MIL-S-19500/267(EL)
AMENDMENT-2
17 January 1966
SUPERSEDING
AMENDMENT-1
23 October 1963

TRANSISTOR, PNP, GERMANIUM
TYPE 2N987

This Amendment forms a part of Military Specification MIL-S-19500/267(EL), 13 May 1963.

Figure 3. Available Power Gain test circuit.

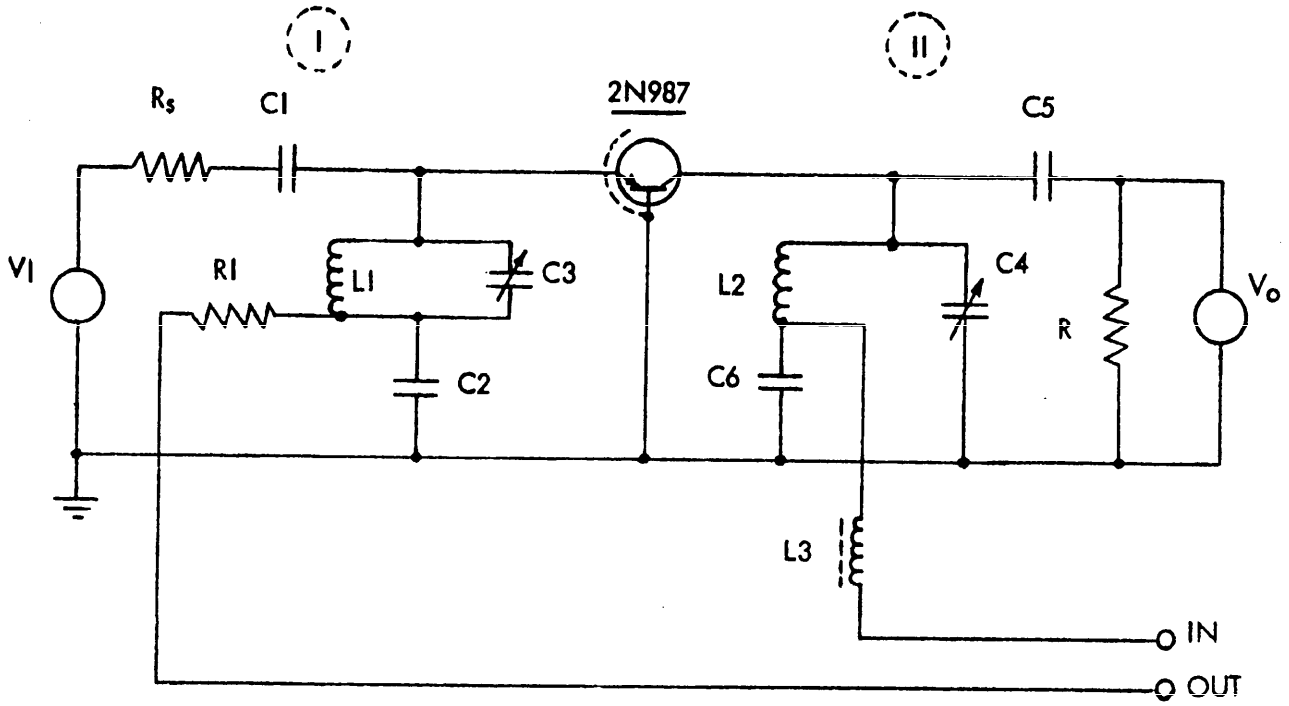
Page 14, Figure 3: Replace with new Figure 3, attached.

$$\text{Available Power Gain} = \left(\frac{V_o}{V_1}\right)^2 \frac{4\,R_s}{R_L}$$

R1 = 10 kohm
R_s = 60 ohm
R is chosen such that the total impedance RL of the tuned circuit II equals 3.3 kohm

C_1 = 1500 uuf
C_2 = 820 uuf
C_3 = 5-25 uuf var.
C_4 = 2-10 uuf var.
C_5 = 220 uuf
C_6 = 820 uuf

L_1 = 0.18 uH
L_2 = 0.18 uH
L_3 = ferrite bead
